CONSTRUCTION SUMMARY		RECEIVED MAY 28 2019	
Mayfield Village 2 (G) - Minnisale Homes Corp.			
PURCHASERS: RAMYA NONAVINAKERE SRINIVA and PRAMOD MUTTANNA SITARAM		TEL: RES.: 647-671-3675	
LOT / PHASE	REG. PLAN #	HOUSE TYPE	
8 / 2	43M-2060	Millwood 1 Elev 3 (4 Bedroom Plan)

MILLWOOD 1

38' LOT • 2,194 SQ.FT.

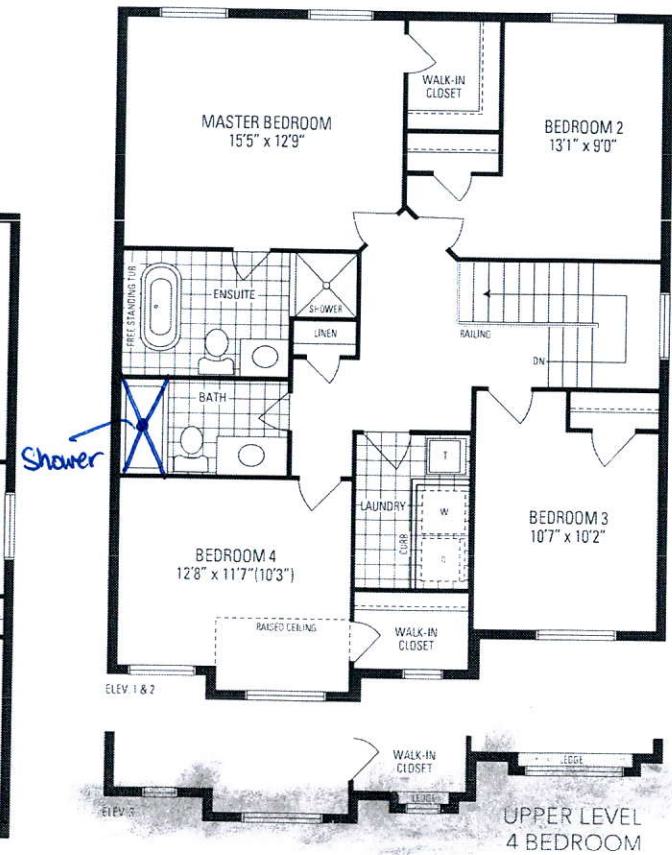
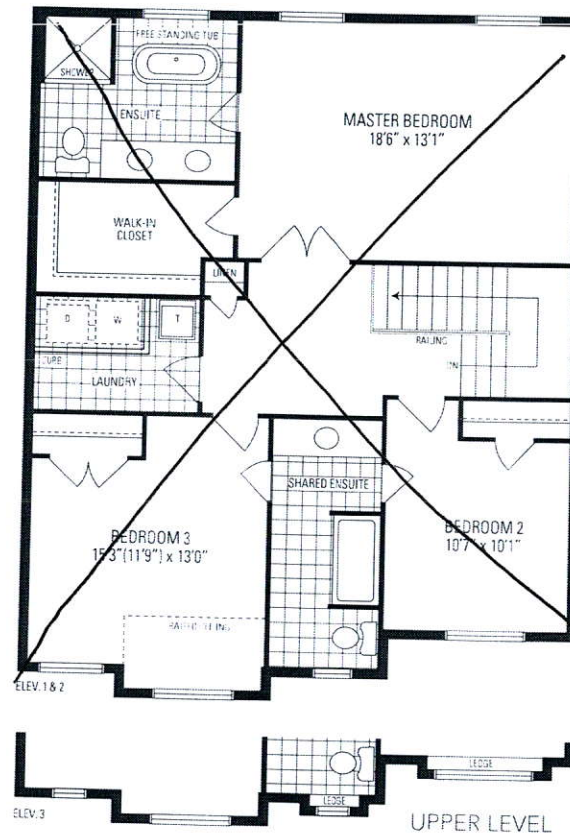
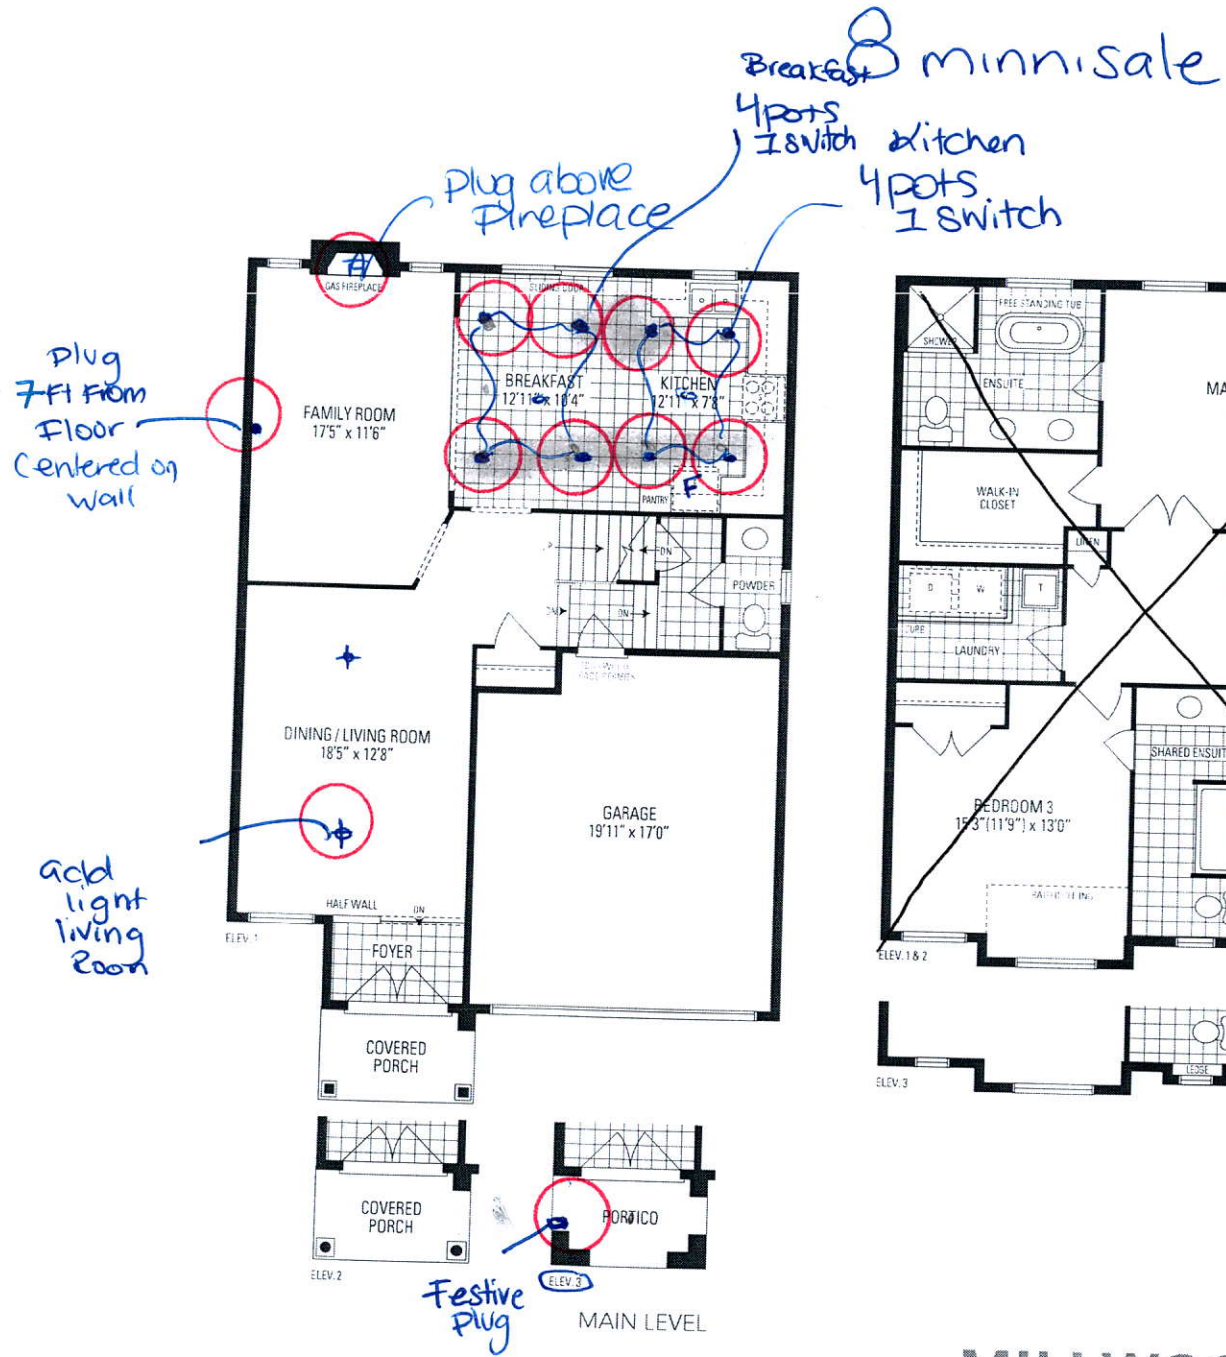
8 - POT LIGHT - LED - FIRST FLOOR INSTALLATION 28May19 Note:	
1 - LIGHT AND SWITCH - NO FIXTURE INCLUDED - LIVING ROOM 28May19 Note:	
1 - PLUG - ELECTRICAL PLUG 7FT FROM FLOOR- FAMILY ROOM- SEE SKETCH 28May19 Note:	
1 - PLUG - ELECTRICAL PLUG - TO BE INSTALLED OVER FIREPLACE 28May19 Note:	
1 - PLUG - ELECTRICAL PLUG WITH GFI AND SWITCH - FOR FESTIVE LIGHTING 28May19 Note:	
1 - 200 AMP ELECTRICAL SERVICE 28May19 Note:

2 - TOE TESTER - ADD TOE TESTER TO SHOWER- MASTER SHOWER AND MAIN SHOWER 28May19 Note:	
1 - 5 FOOT SHOWER WITH SLIDING GLASS CHROME DOORS IN LIEU OF TUB- MAIN BATHROOM 28May19 Note:
